APPLICATION FOR SUBMITTAL OF POST-APPROVAL DOCUMENT

APPLICATION FOR SUBMITTAL OF POST-APPROVAL DOCUMENT

drawing no.:
S-N2.1

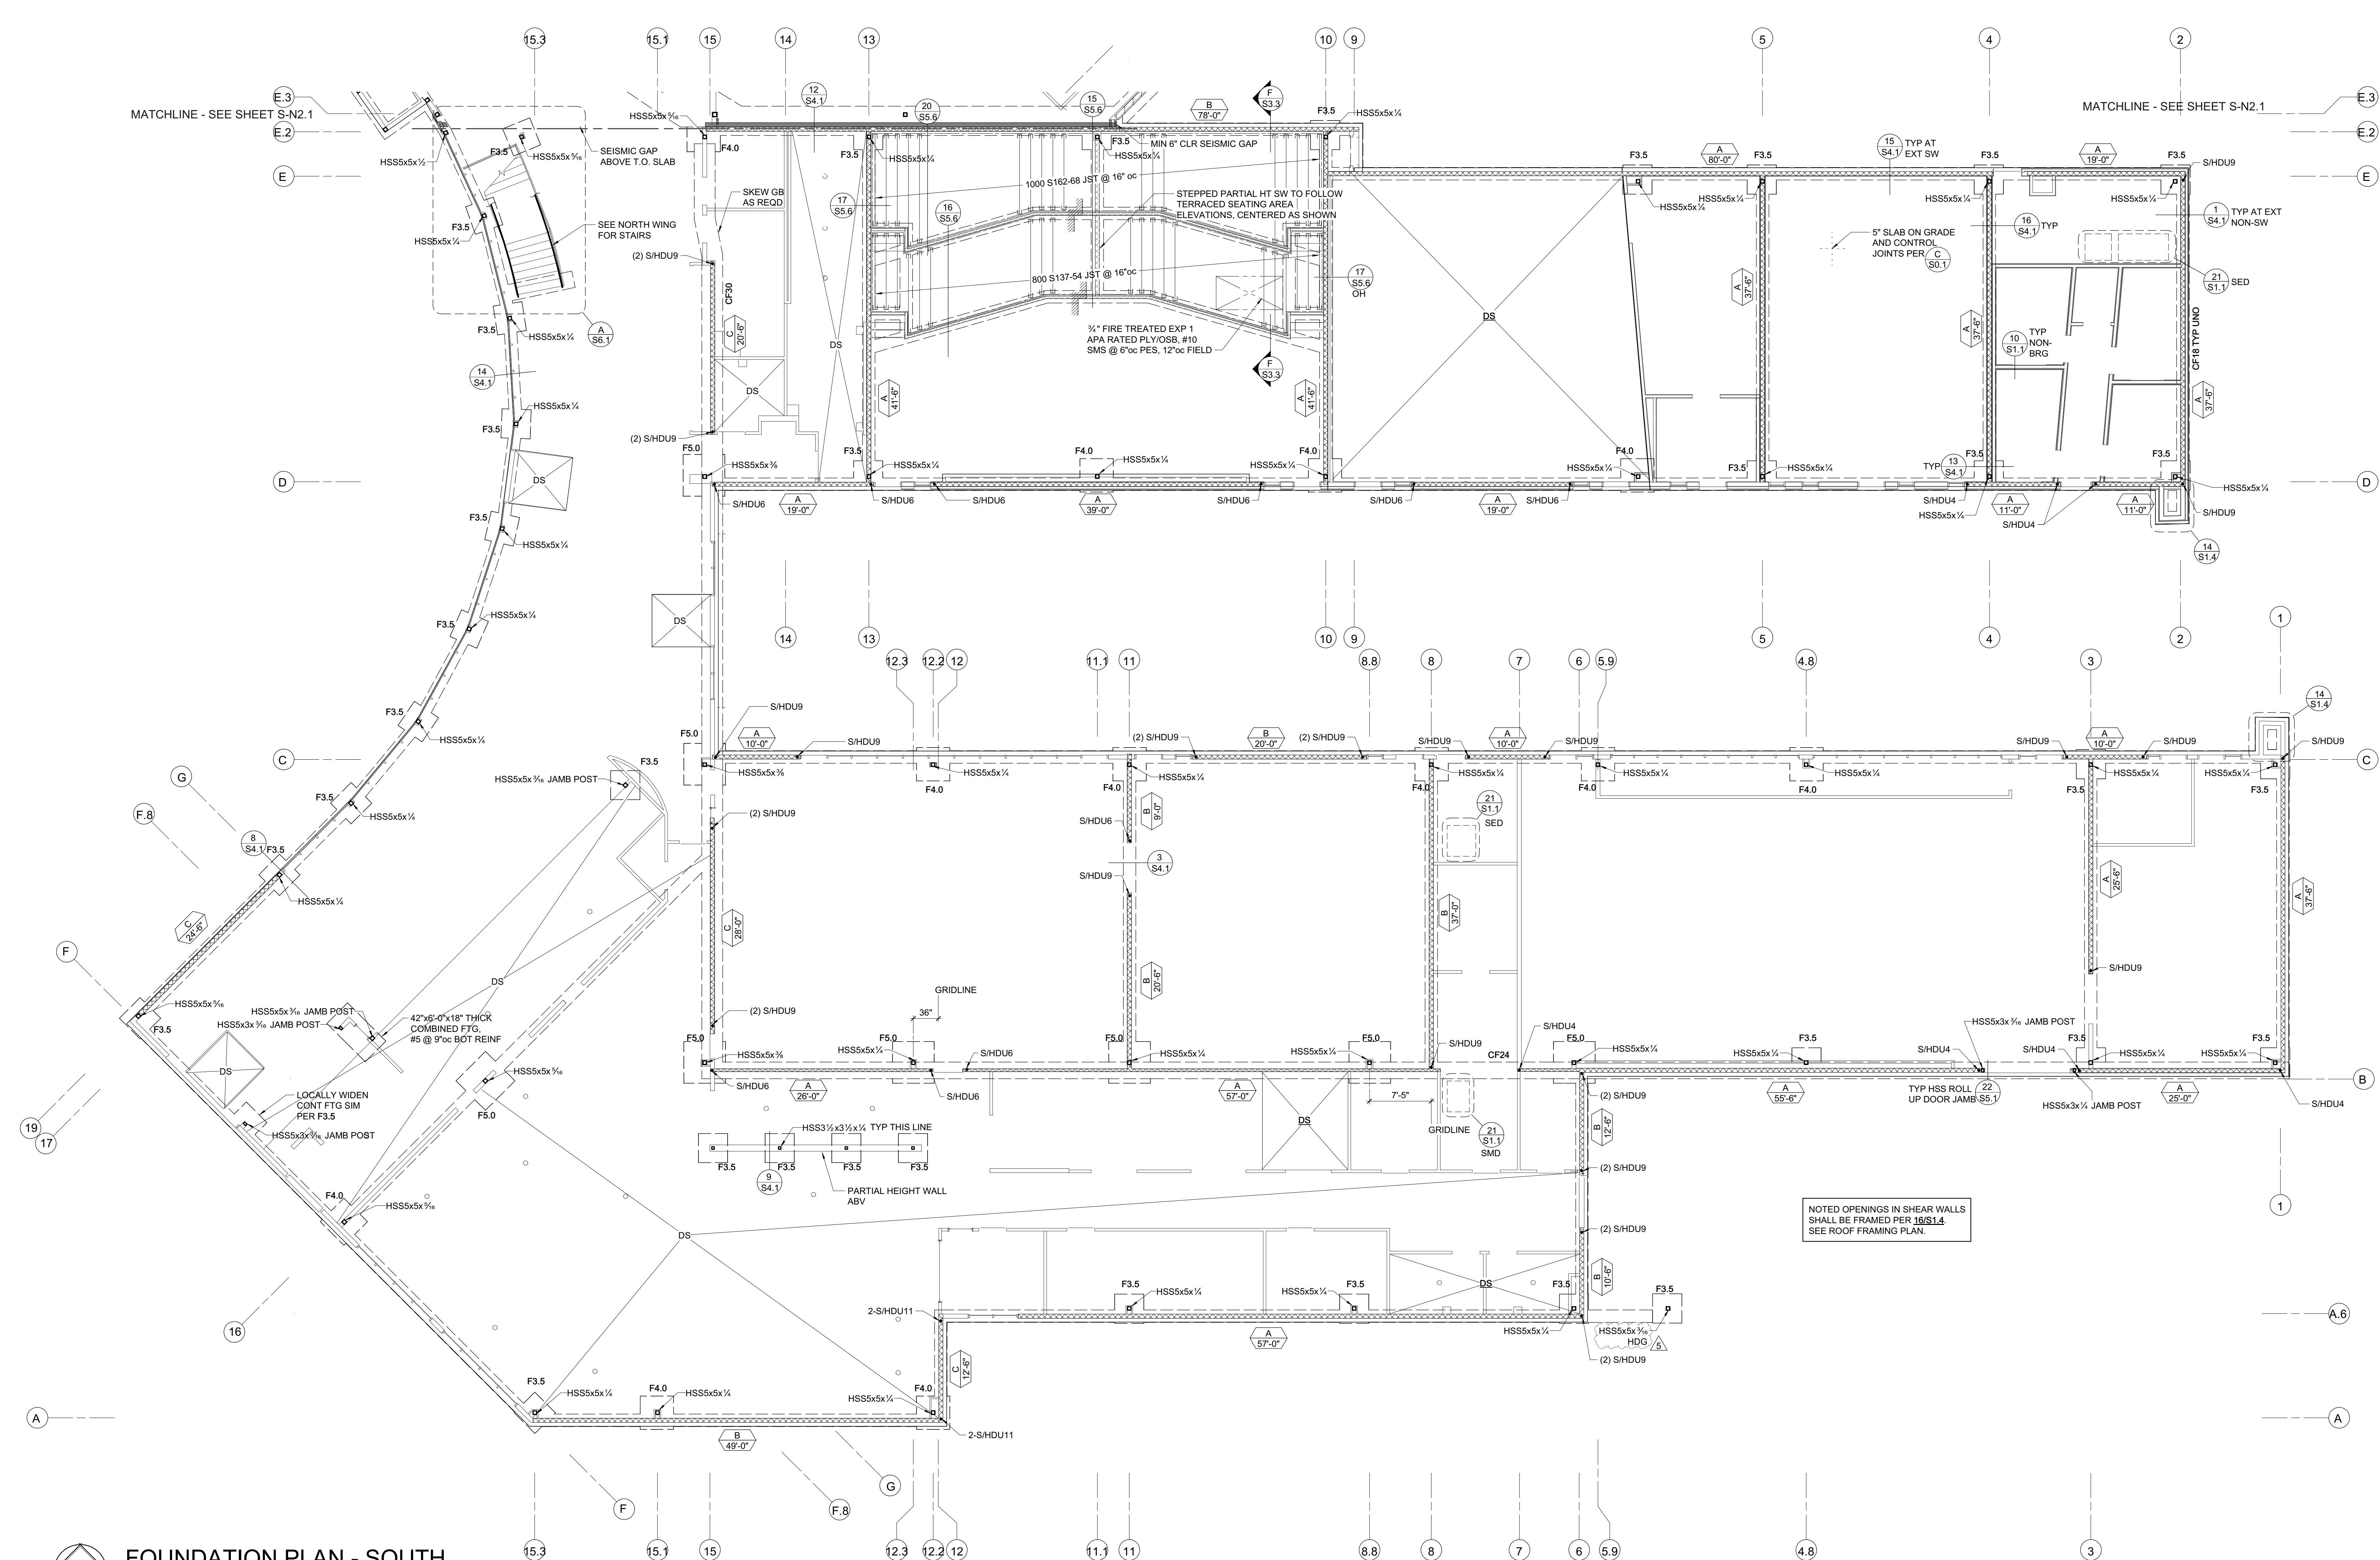
- t. **S-N2-1 -** Added references to new S1.2 details.
- u. **S-S2-1 -** Added note to HDG steel at food service canopy.
- v. **S-S2-2 -** Added note to HDG steel at food service canopy.
